BB7  
3671 - Hillingdon  
Proposed Disabled Refuge Locations  
BB-DRC-3671-02  
10<sup>th</sup> January 2020  
Review by: Thomas Gibbins  
Authorised by: Dane Owen

**5 Building 2 - Roof Plan**  
1 : 200

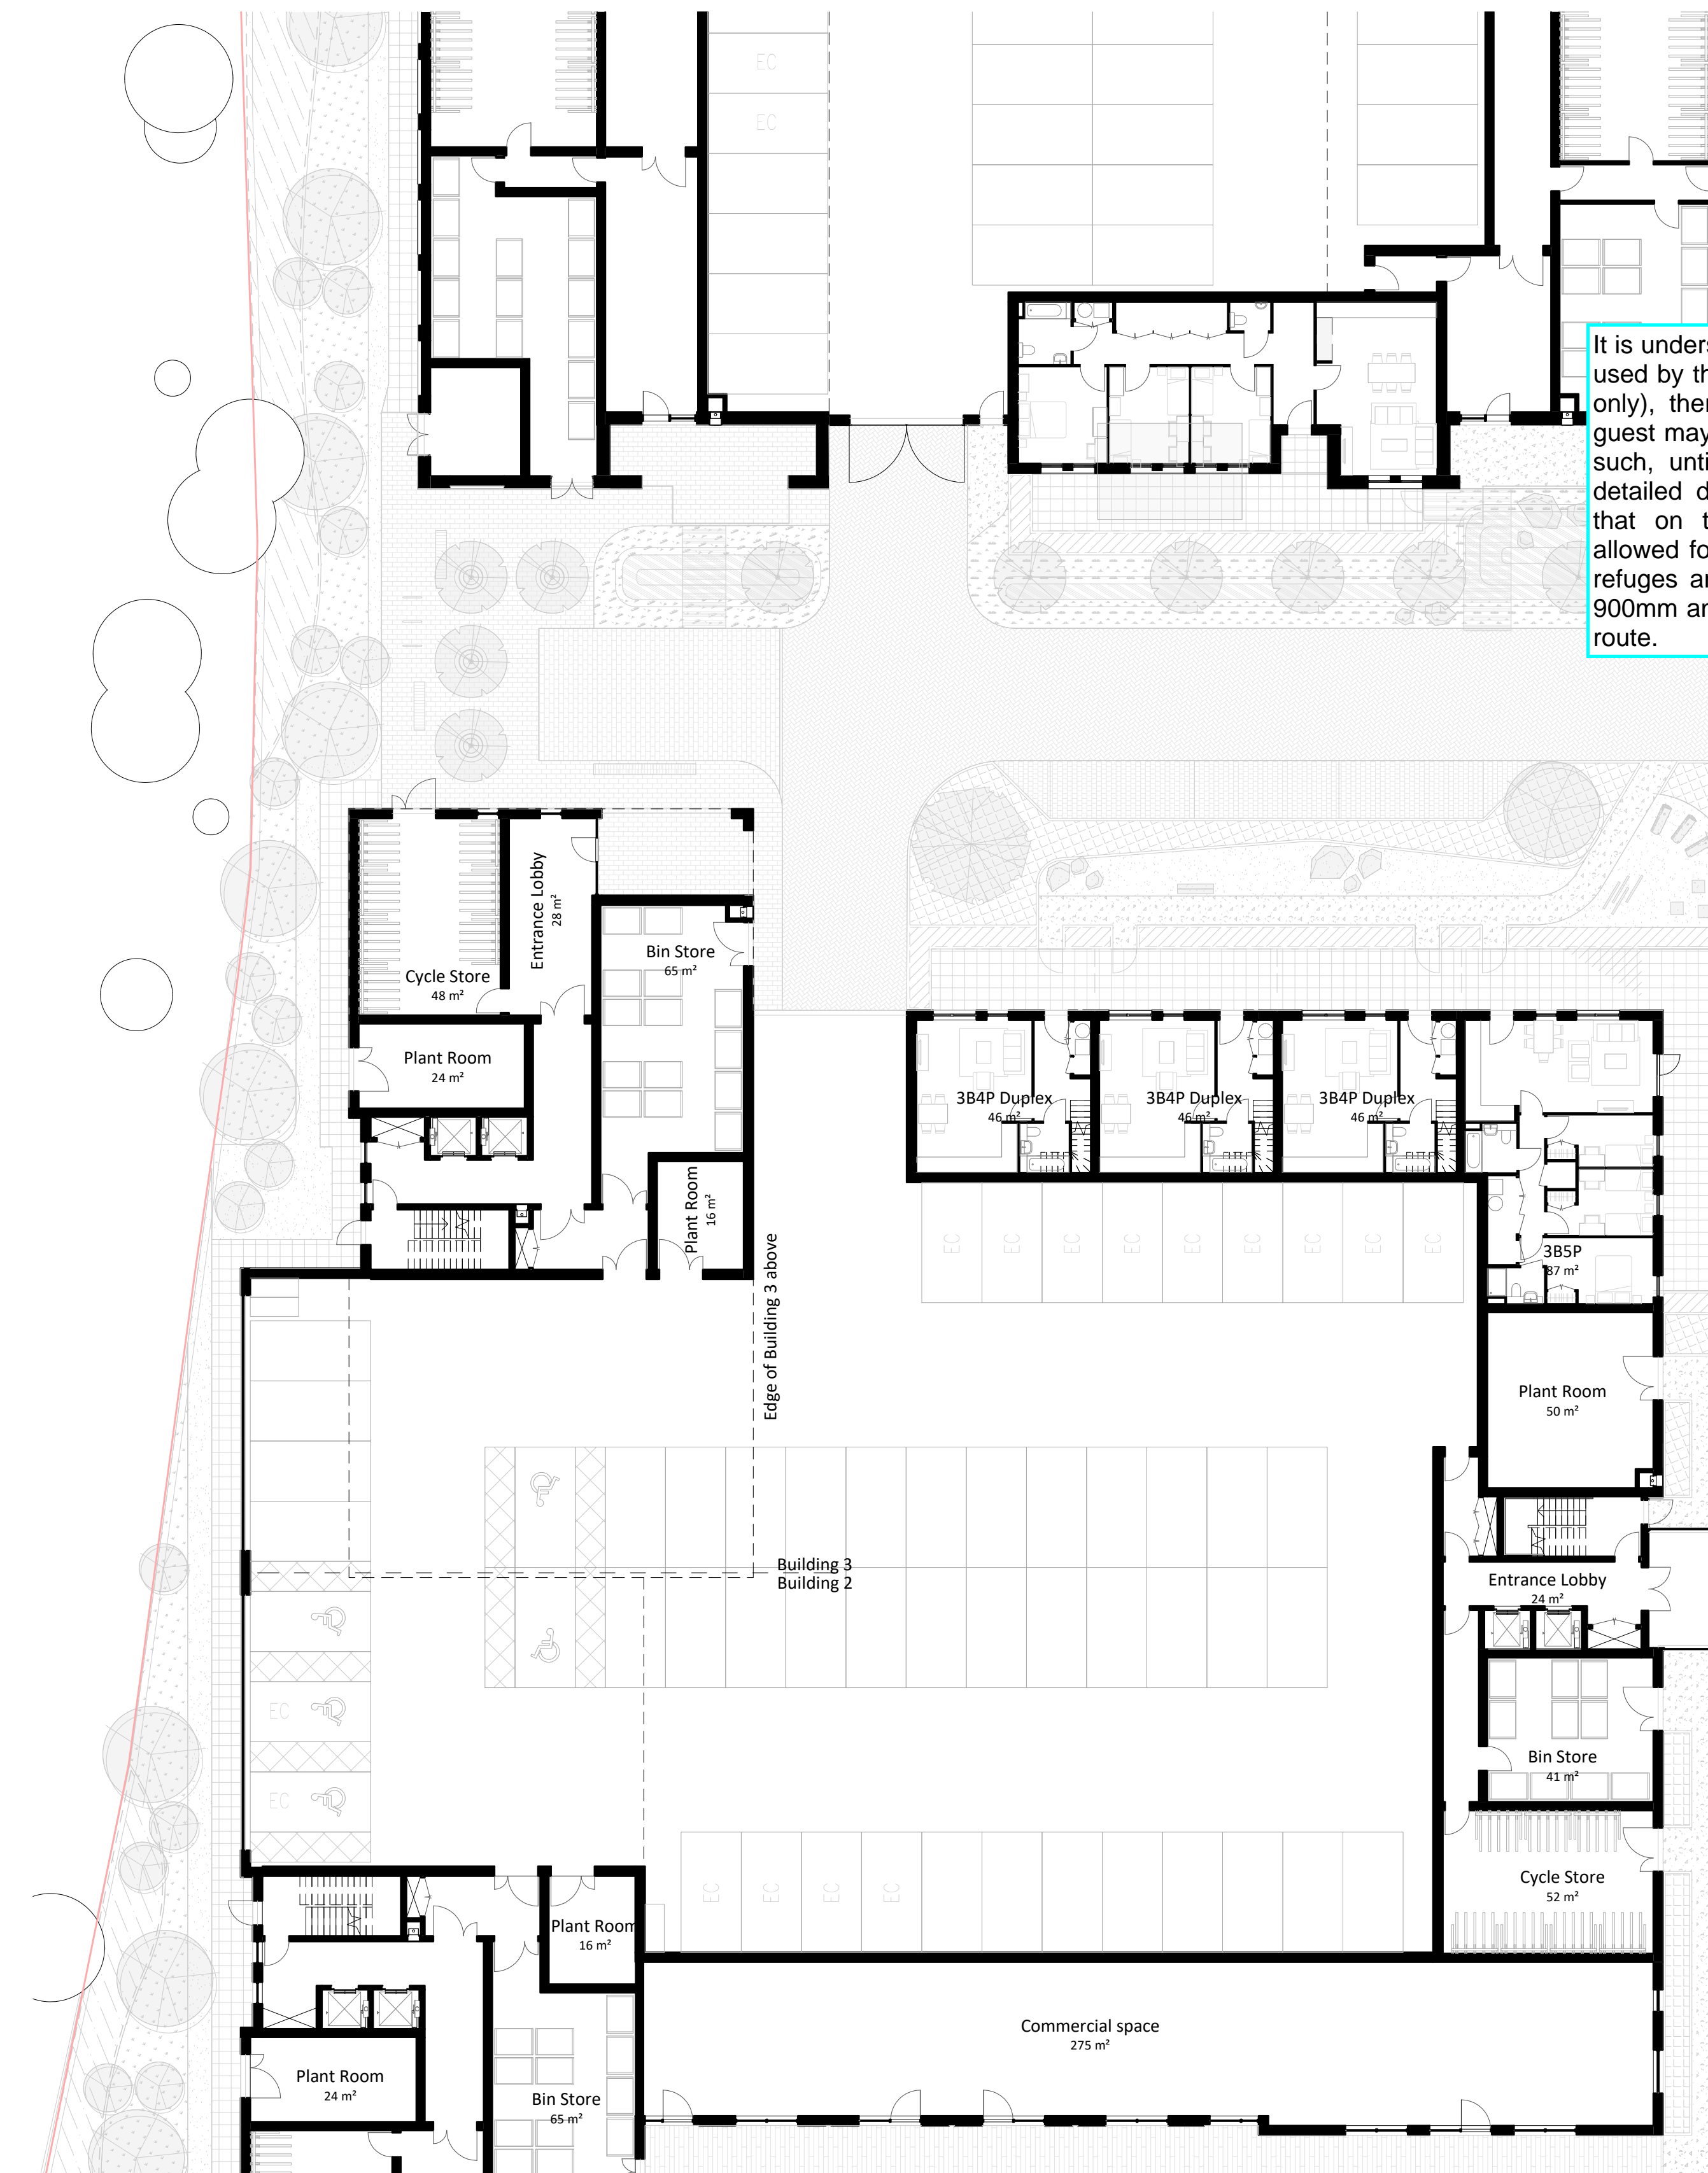
To meet the escape travel distances for the roof terrace, an alternative escape route is required to be provided. In addition, a disabled refuge is required to be provided in the lobby/staircase.

It is understood that the roof terrace is to be used by the residents (i.e. not maintenance only), therefore it's a risk that a disabled guest may be present in a fire scenario. As such, until agreed to be omitted at the detailed design stage, it is recommended that on this level a disabled refuge is allowed for in the staircase/lobby. Disabled refuges are to be a minimum 1400mm by 900mm and are ton not impede the escape route.

**5 Building 3 - Roof Plan**  
1 : 200

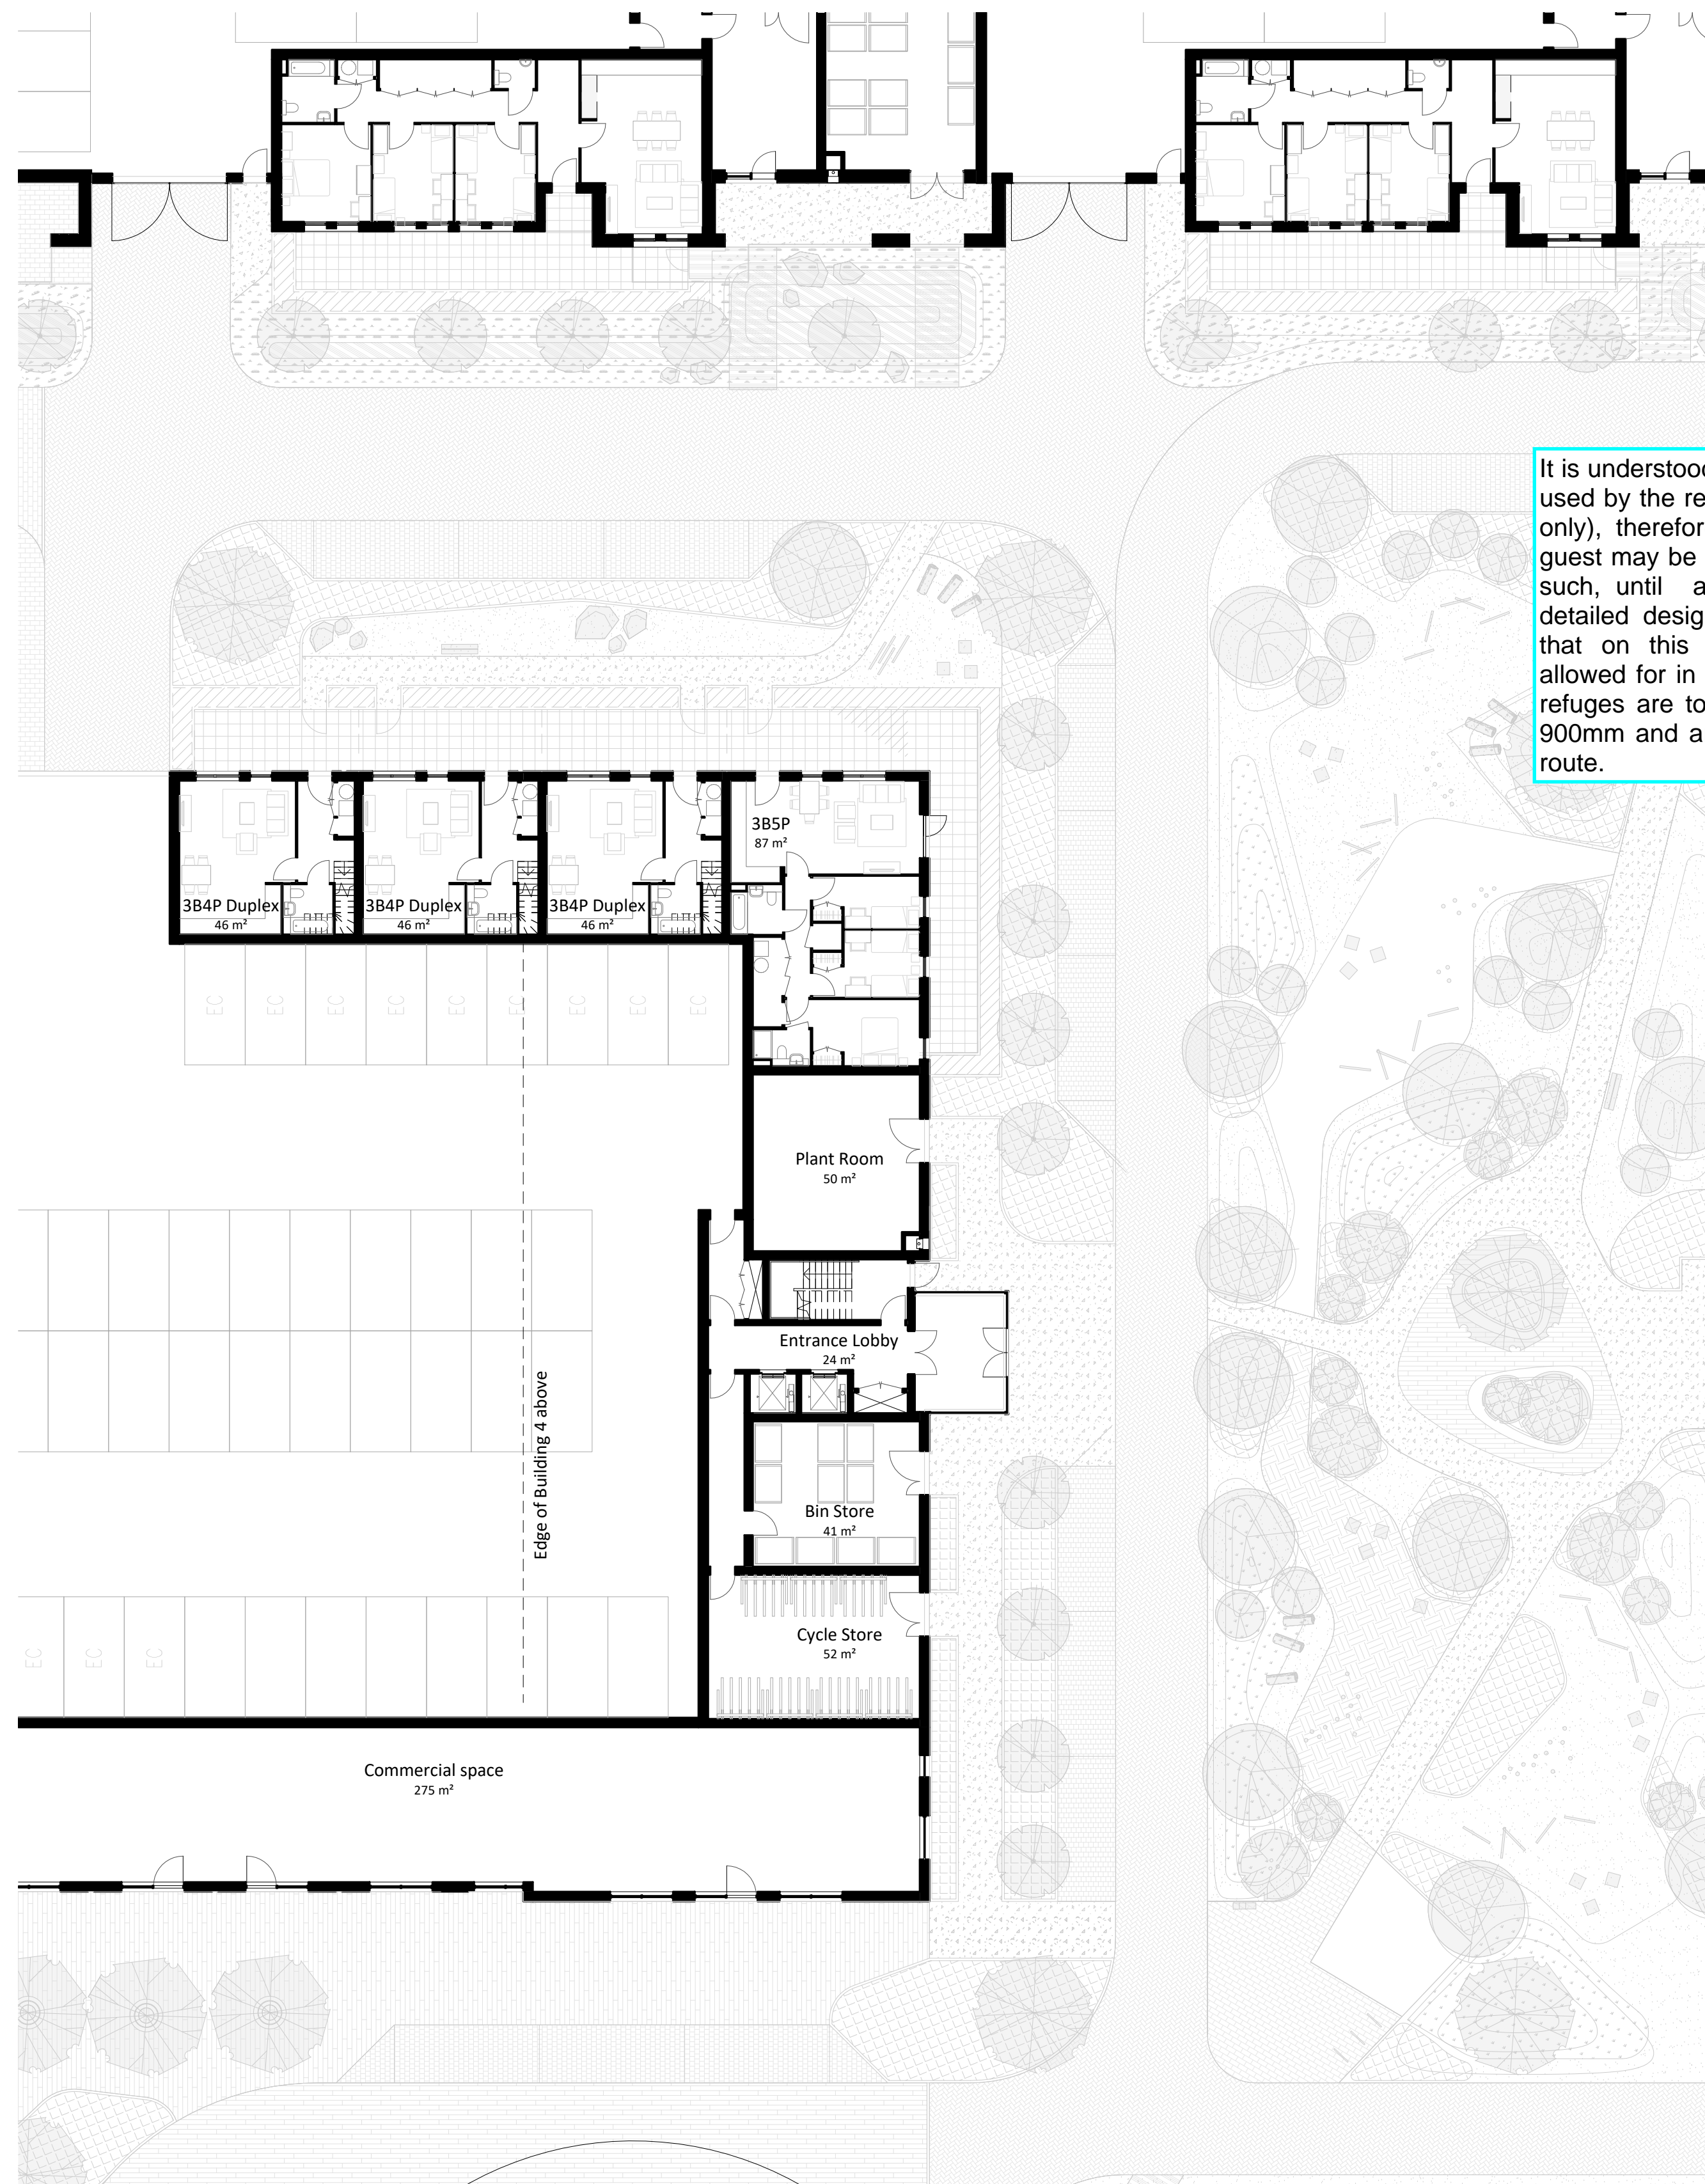
It is understood that the roof terrace is to be used by the residents (i.e. not maintenance only), therefore it's a risk that a disabled guest may be present in a fire scenario. As such, until agreed to be omitted at the detailed design stage, it is recommended that on this level a disabled refuge is allowed for in the staircase/lobby. Disabled refuges are to be a minimum 1400mm by 900mm and are ton not impede the escape route.
